PLANNING AND ZONING COMMISSION PUBLIC HEARING MEETING
CITY HALL, 385 SOUTH GOLIAD STREET, ROCKWALL, TEXAS
FEBRUARY 10, 2026 IN THE CITY COUNCIL CHAMBERS AT 6:00 PM

(3) **P2025-045 (HENRY LEE)**

(4) **SP2025-048 (HENRY LEE)**

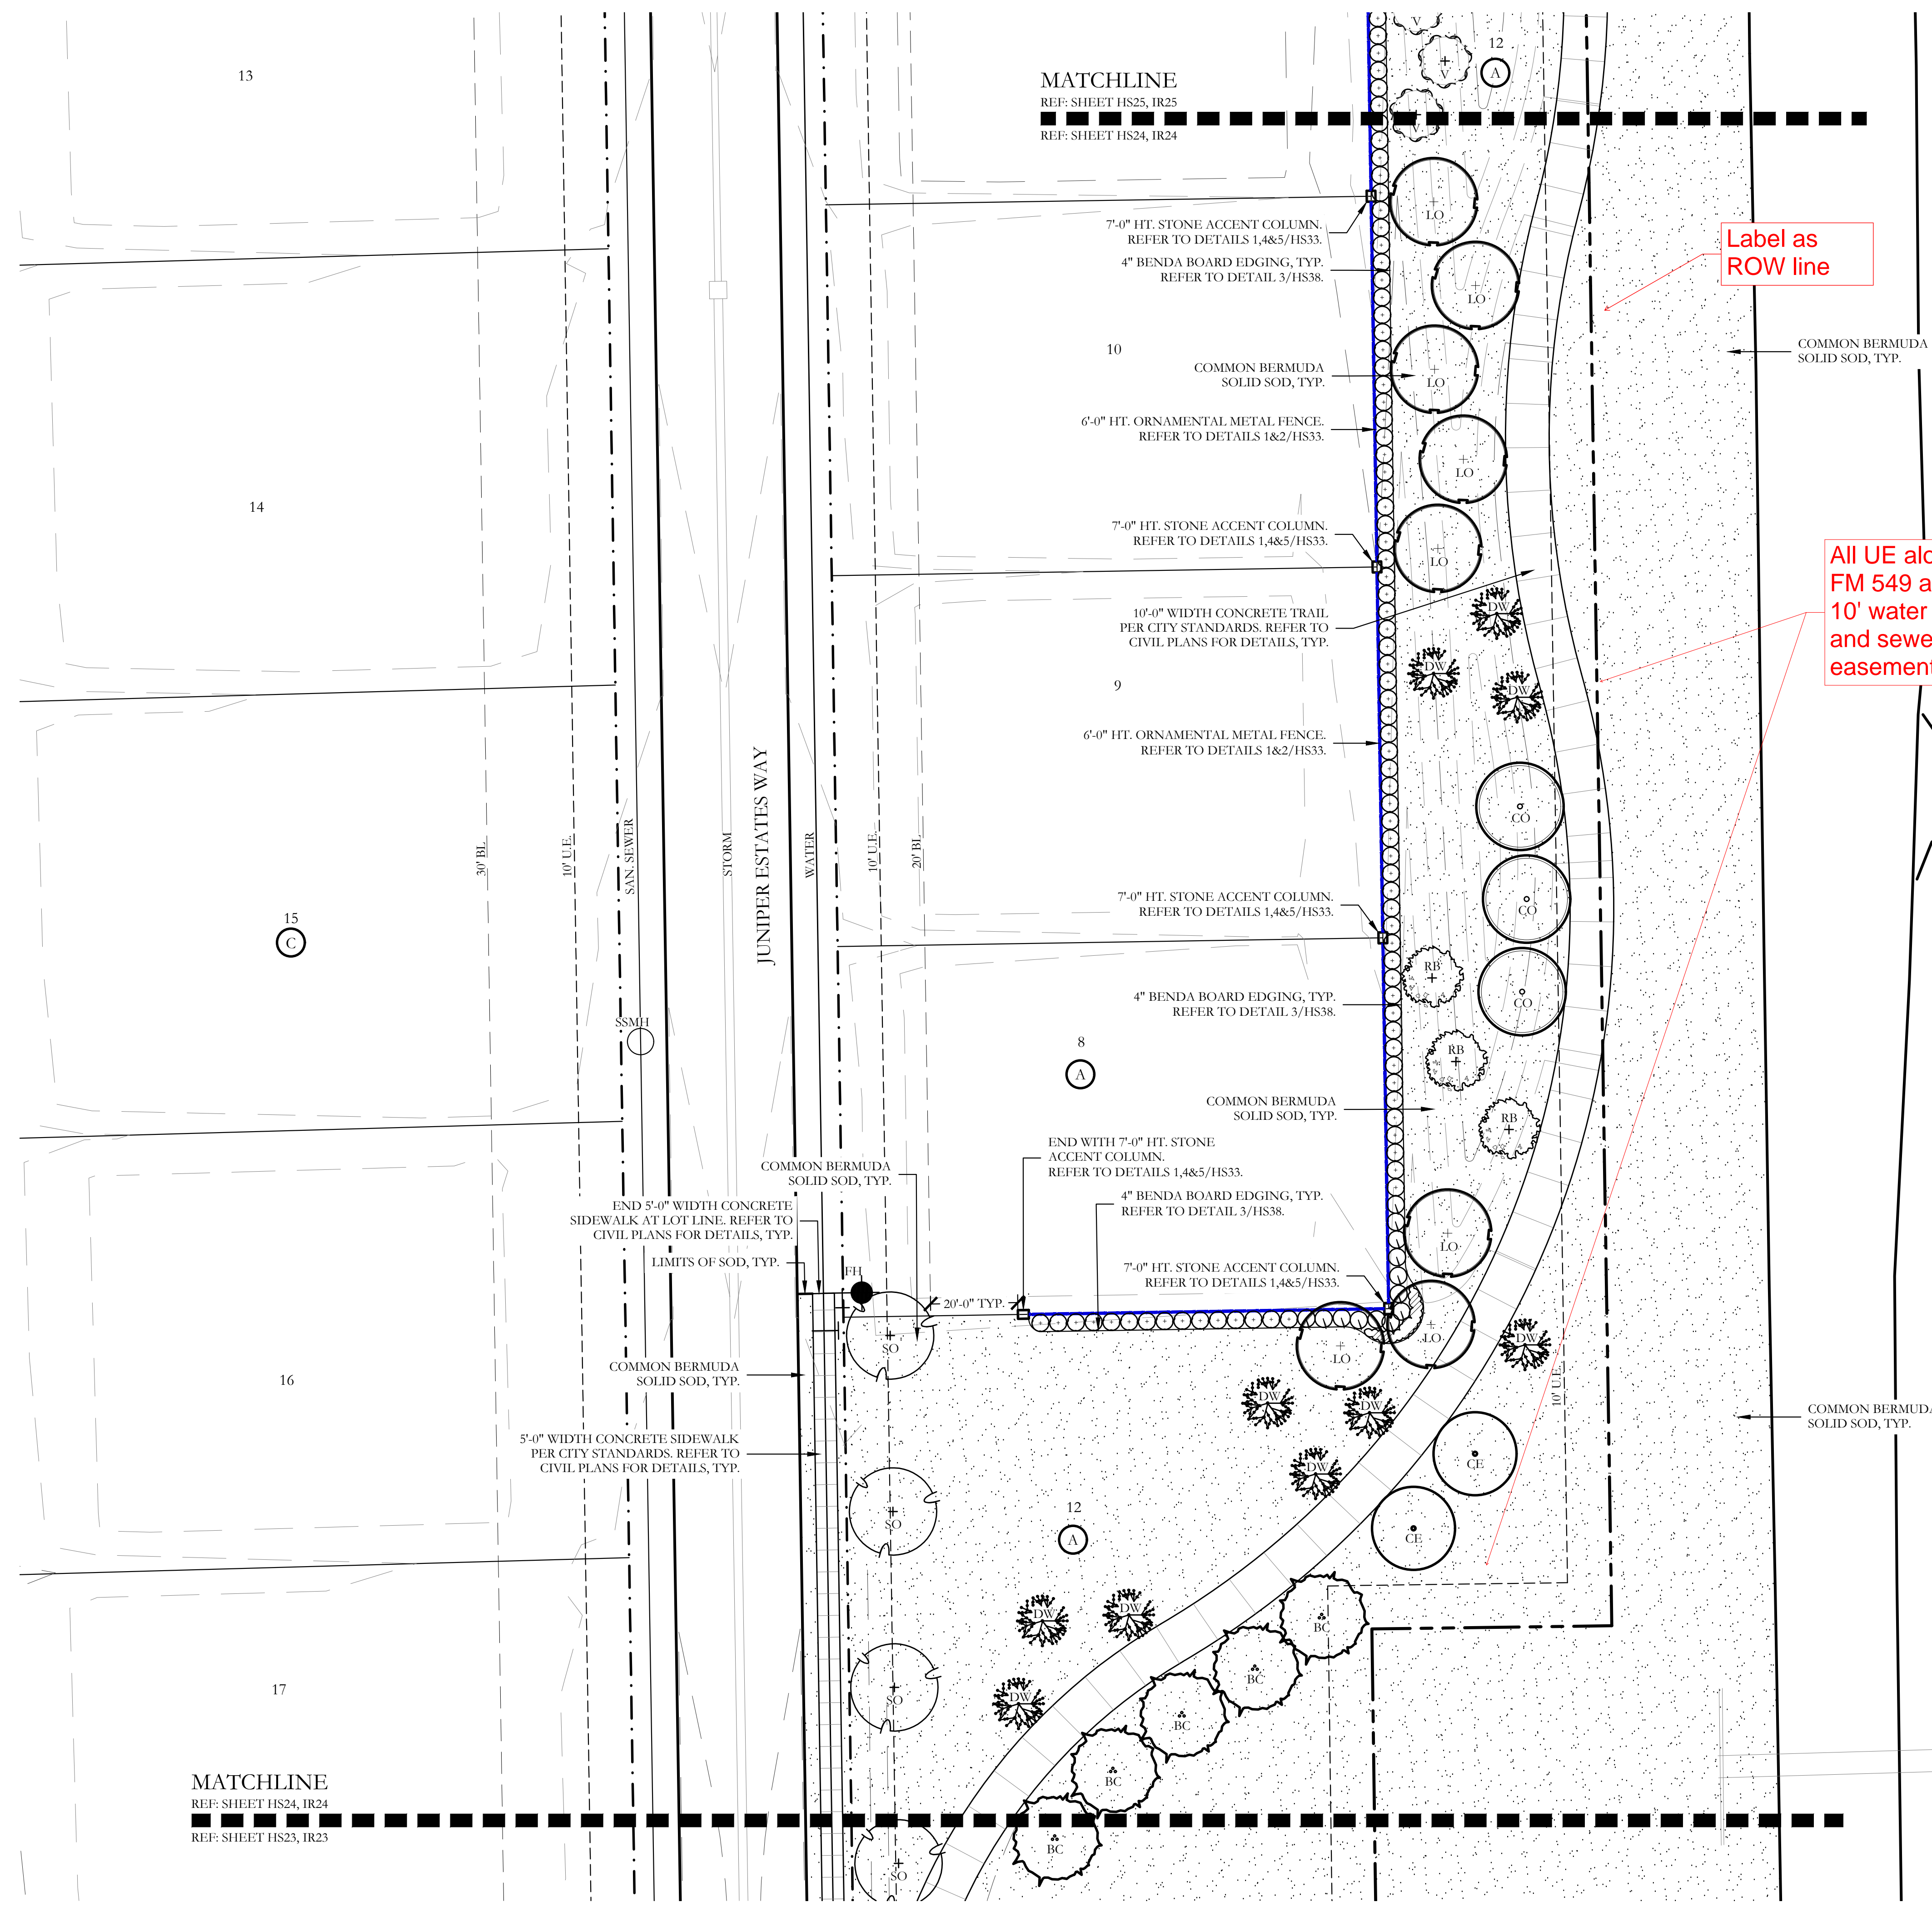
All UE along FM 549 are 10' water and sewer easements

Label as ROW line

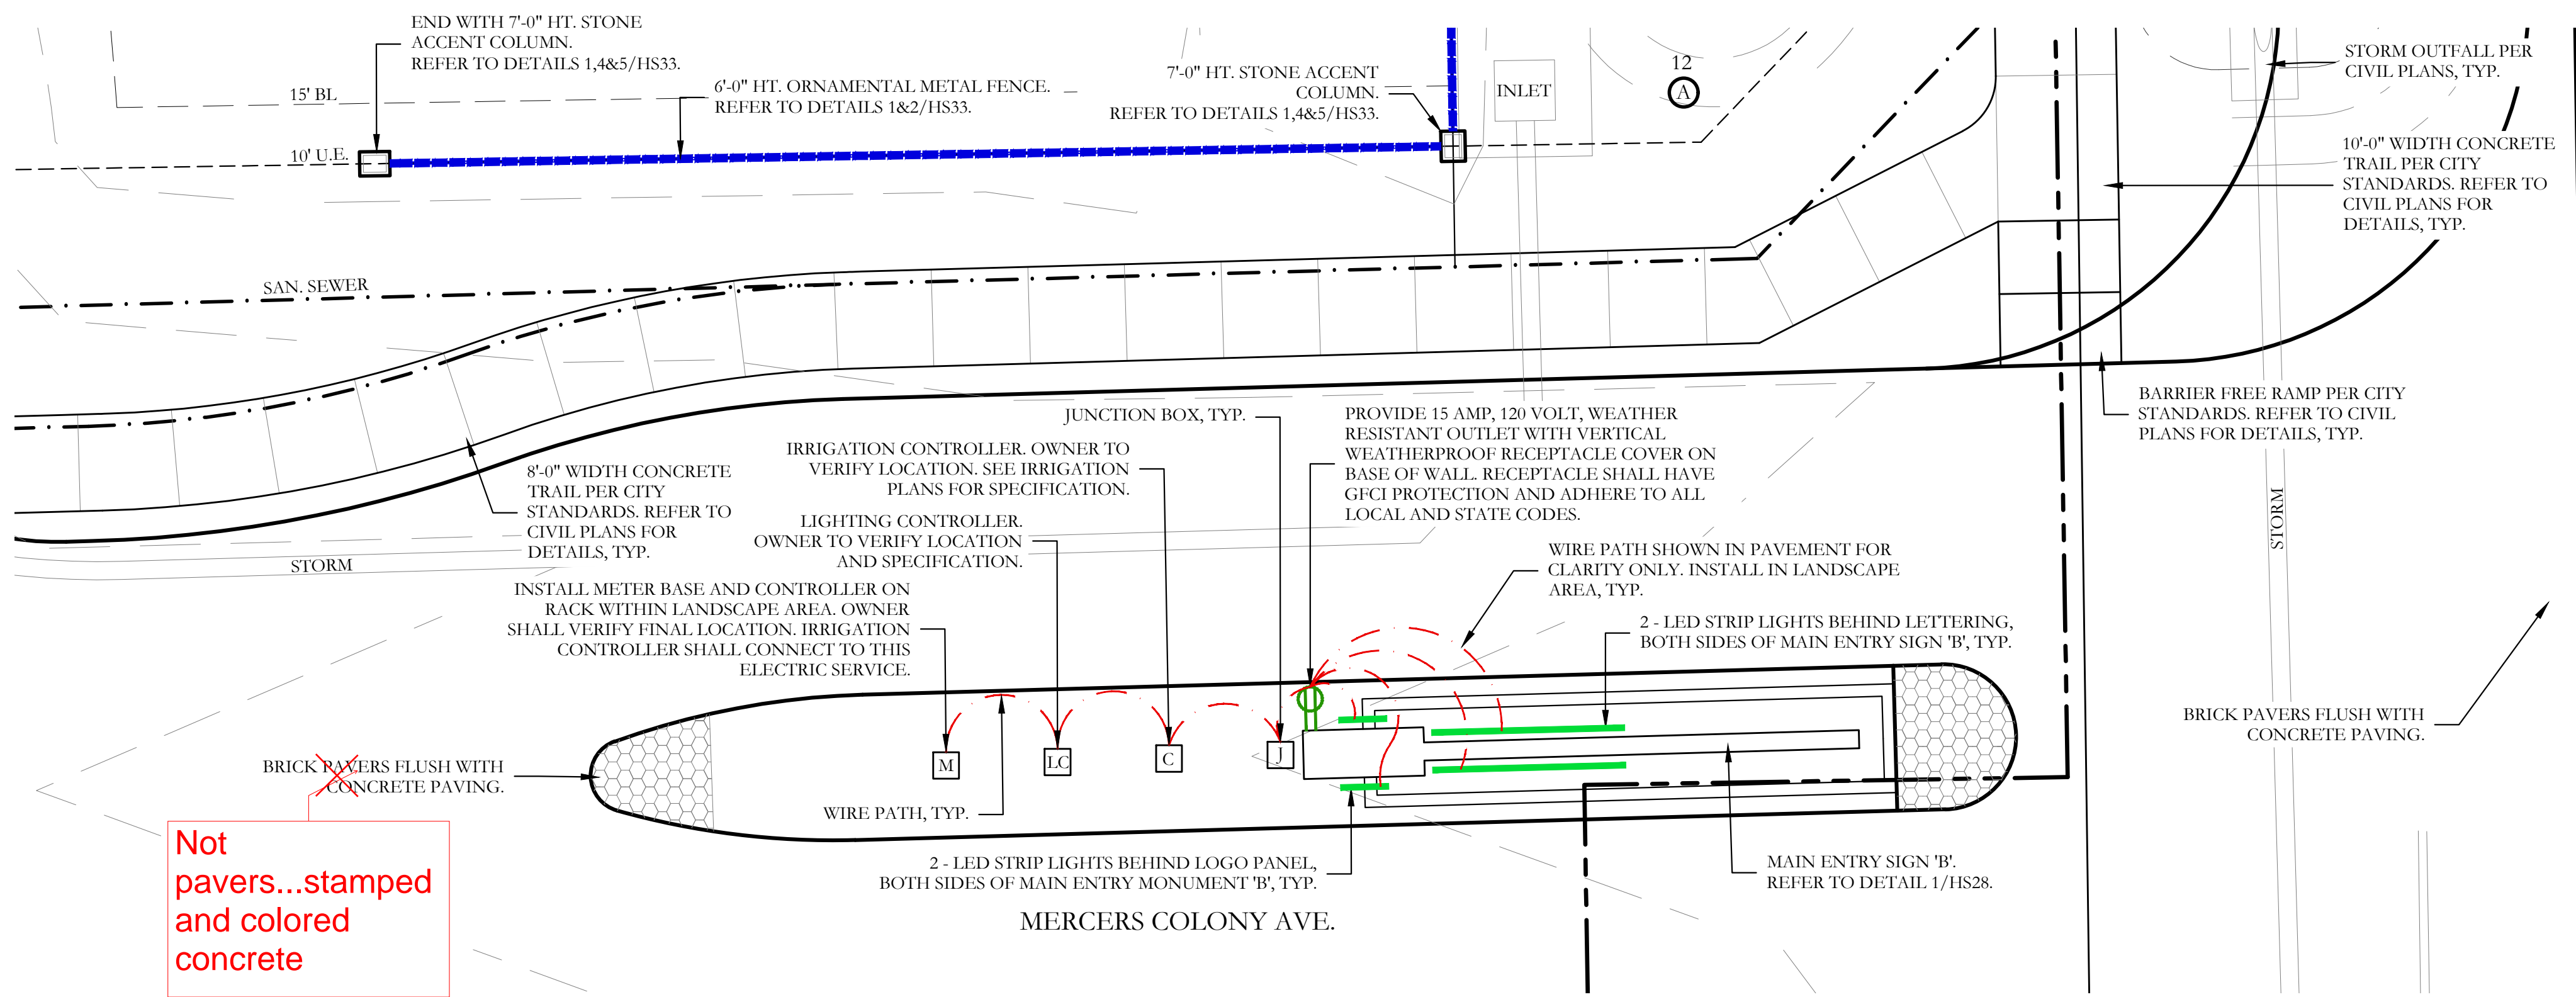
Not pavers...stamped and colored concrete

1 MAIN ENTRY LIGHTING AT FM 549 AND MERCER COLONY AVE.

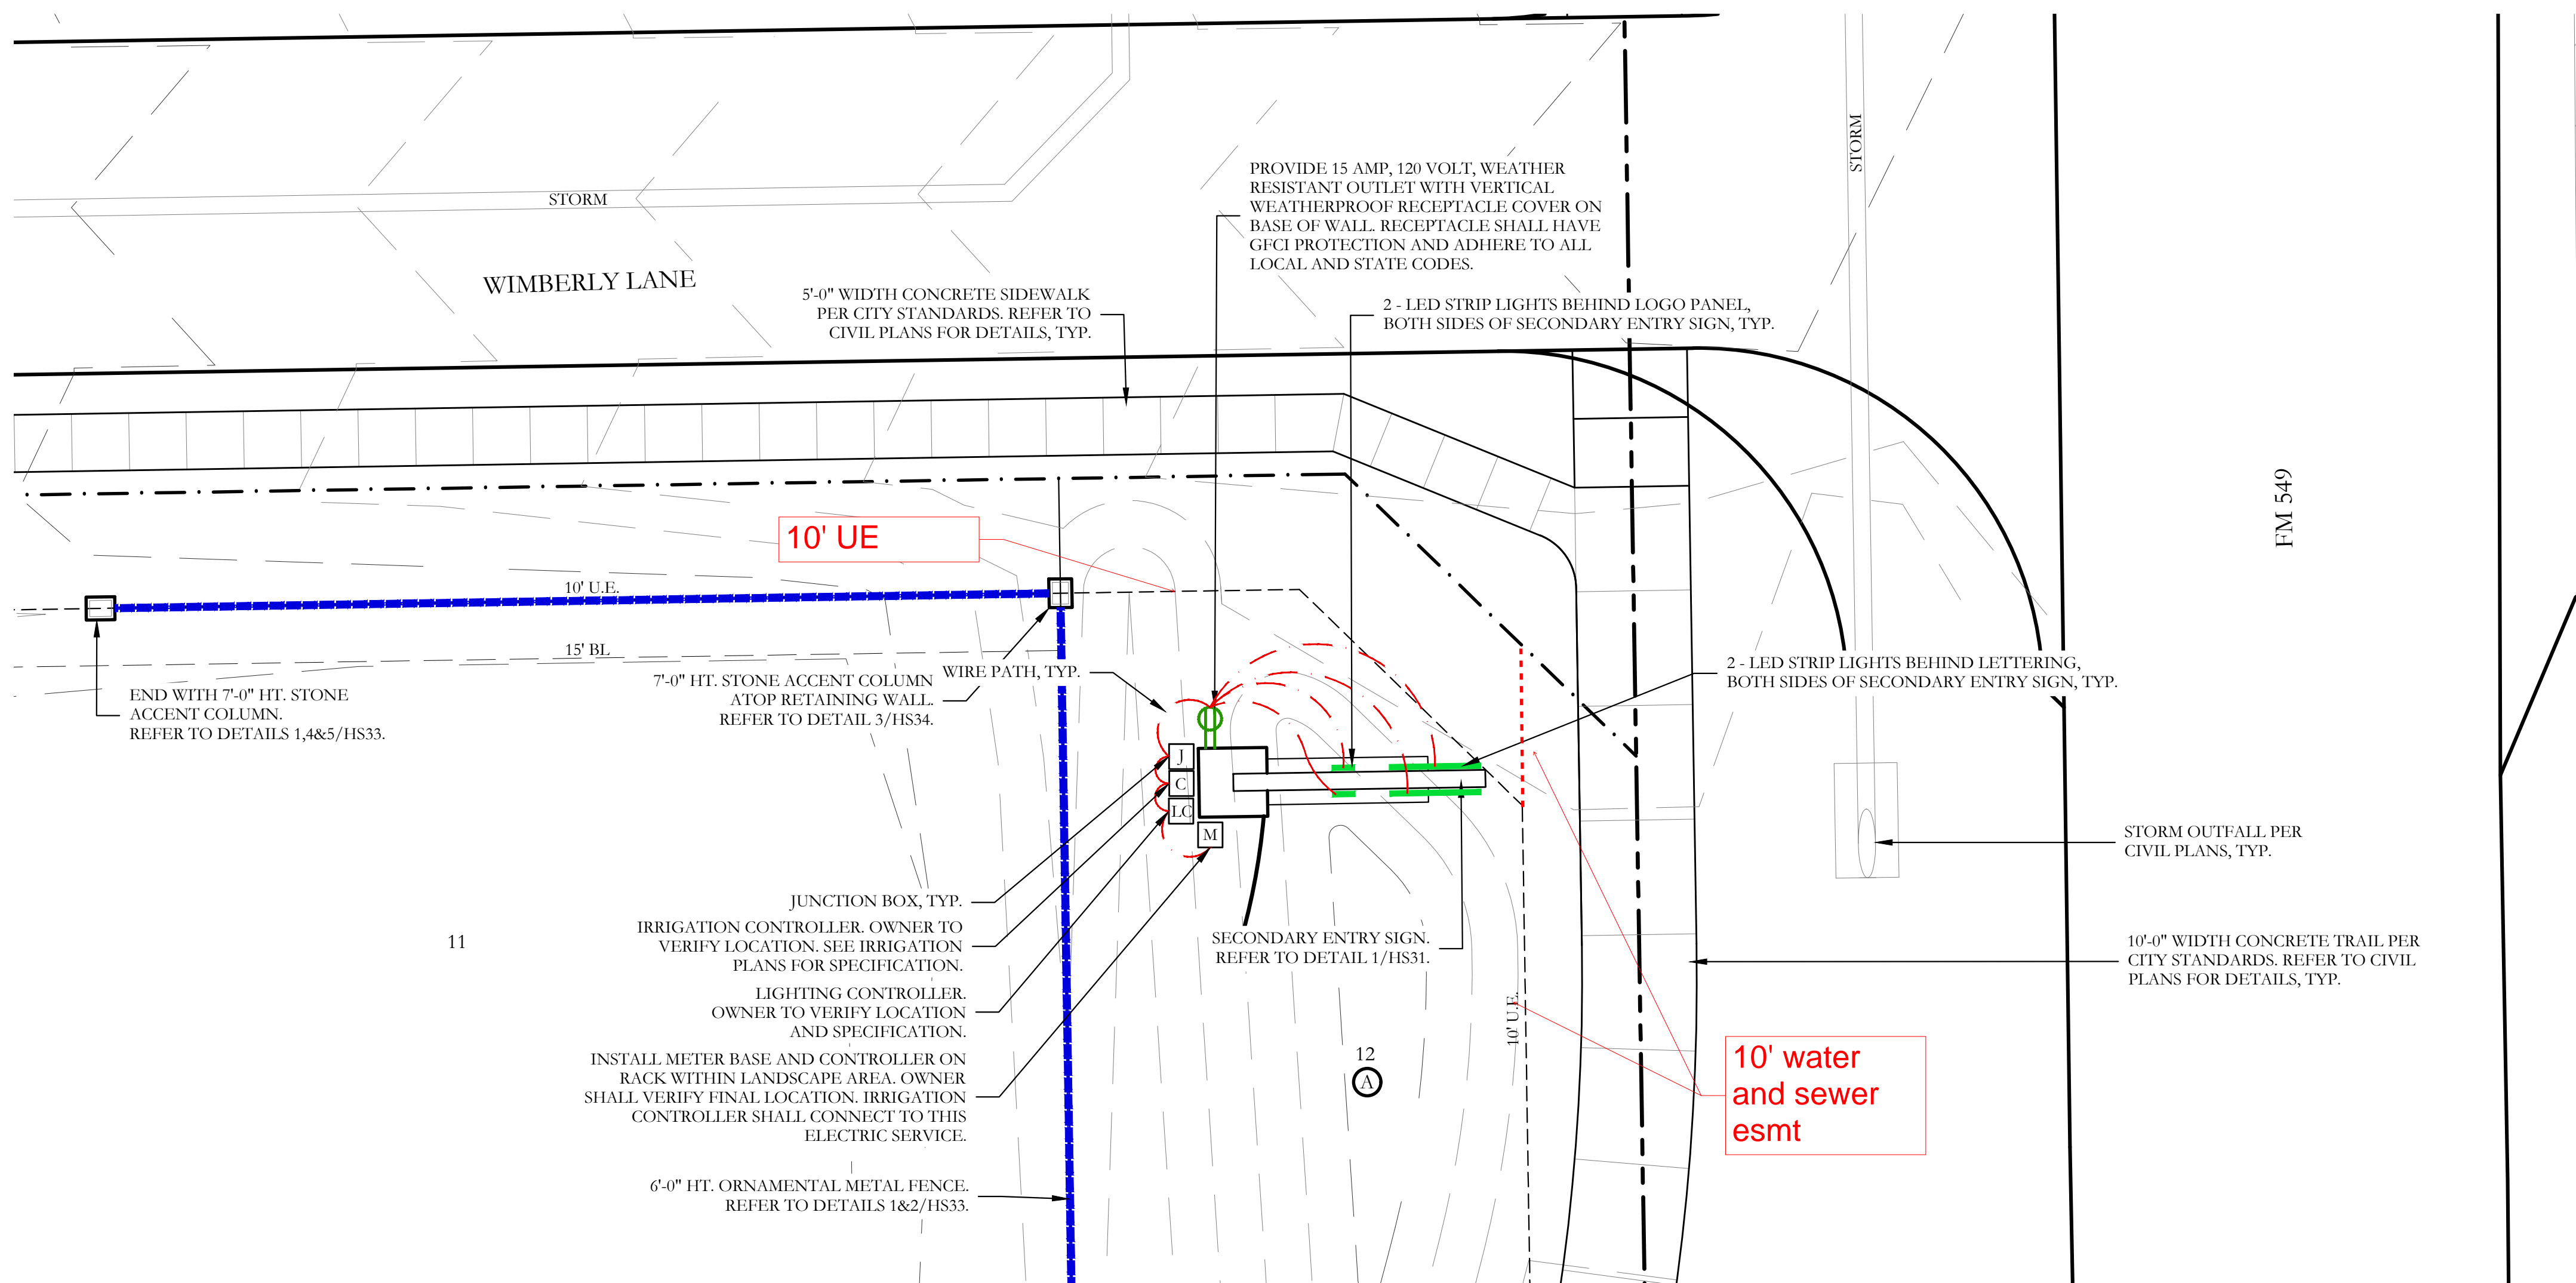
10' water and sewer esmt
